AGENDA

TROUTDALE PLANNING COMMISSION REGULAR MEETING

**CITY OF TROUTDALE
TYPE III PROCEDURE
7-LOT SUBDIVISION WITH LOT LINE ADJUSTMENT,
VARIANCE AND TREE REMOVAL
FILE NO. 15-018 CHERRY PARK**

STAFF REPORT
May 13, 2015

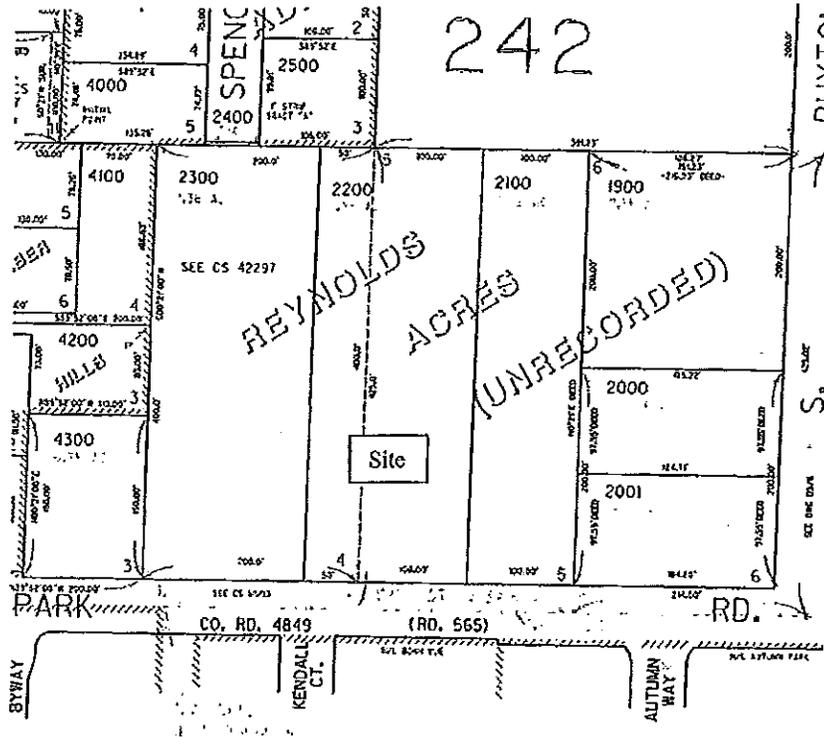
- 5. Any alteration of the storm water discharge onto the right-of-way requires a Discharge Permit.**

Any alteration of storm water drainage to the existing discharge needs to be reviewed by the County. Increased run-off to incorporated Multnomah County could negatively impact the roadway system. Please contact our office for questions regarding this requirement.
